STRATHFIELD COUNCIL **APPROVAL** DA2015/100/03 Date: 20/12/2017

S96 NOTES:

PROPOSED RESIDENTIAL DEVELOPMENT 84 CENTENARY DRIVE, STRATHFIELD NSW 2135 CHECKED BY: NM DATE: 038-S96-04 JULY 2017

Roof Building B

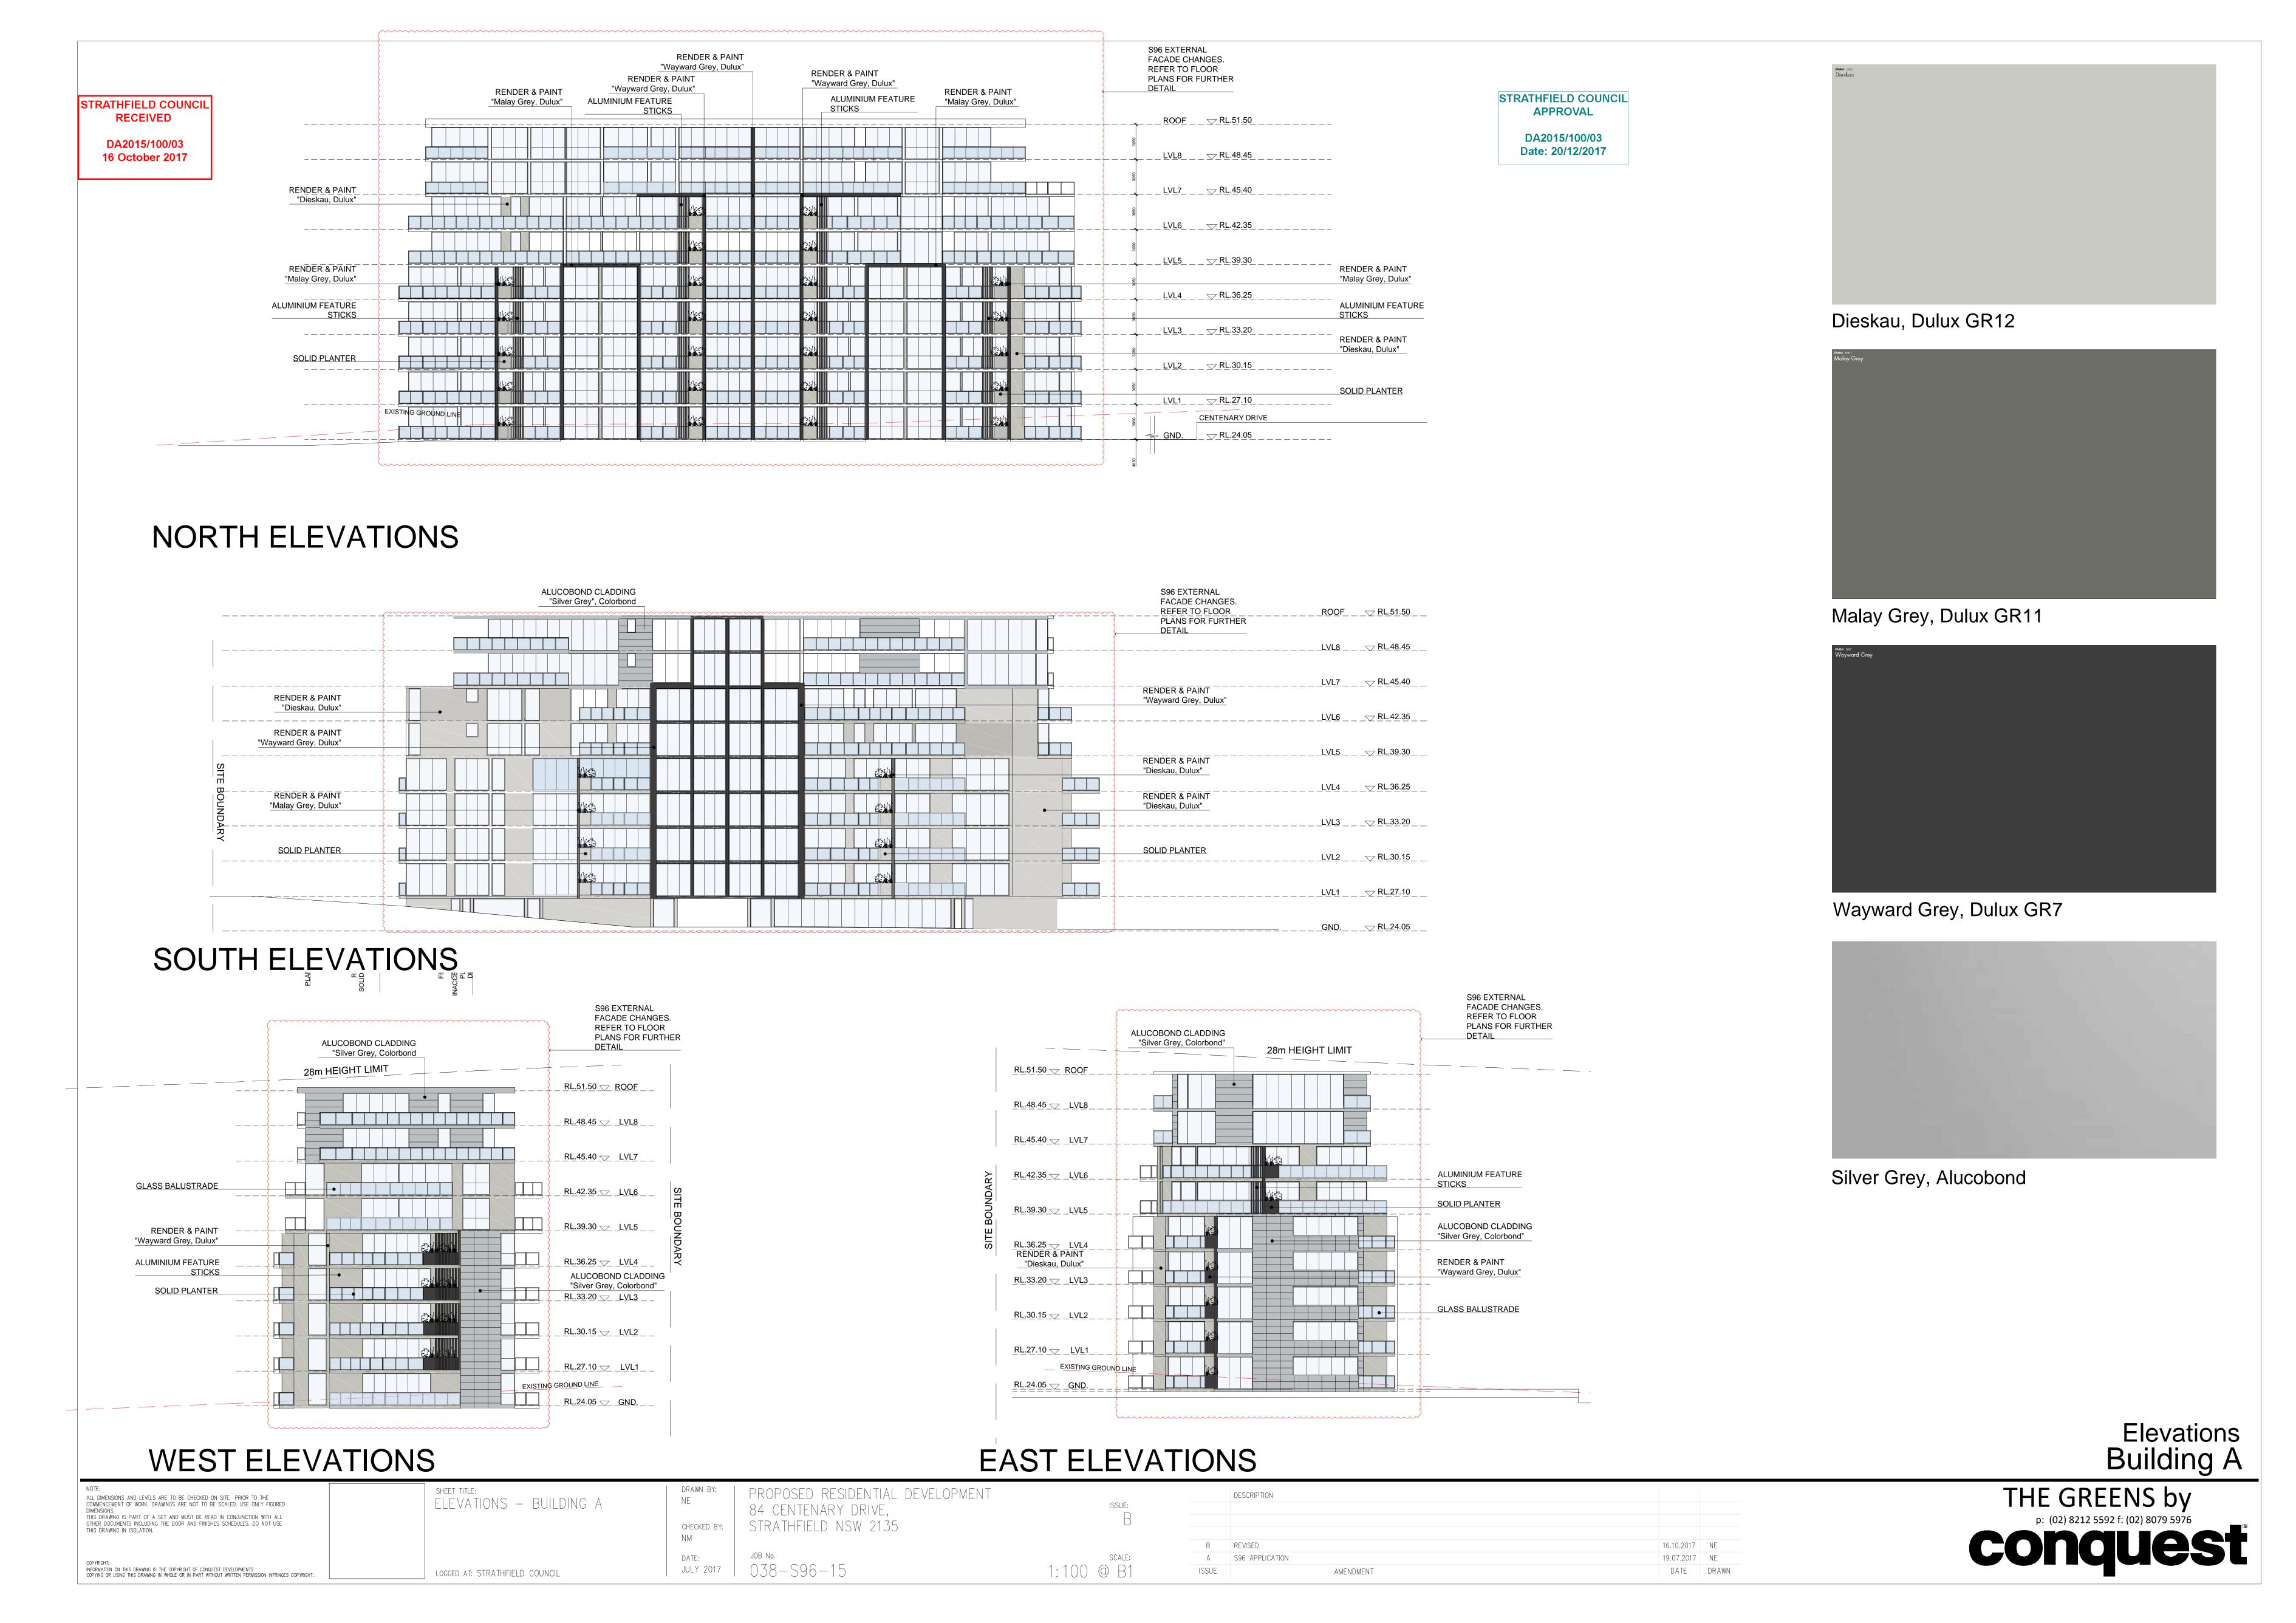
- 1. ALL SOLID BALUSTRADES NOW TO BE GLASS BALUSTRADES ASIDE FROM RELOCATED SOLID PLANTER PORTIONS
- 2. SOME BALCONIES RECONFIGURED
- 3. SOLID PLANTERS AND ALUMINIUM FEATURE STICKS ADDED4. DELETION OF 2X ADDITIONAL LIFTS AT
- EACH BUILDING CORE
- 5. ALL GLAZING TO LIVING AND BEDROOMS RECONFIGURED TO FULL HEIGHT
- 6. ROOF PROFILE RECONFIGURED
- 7. NO CHANGES TO APPROVED BUILDING FOOTPRINT OR GFA

DA APPROVED BALCONY CONFIGURATION S96 PROPOSED BALCONY CONFIGURATION
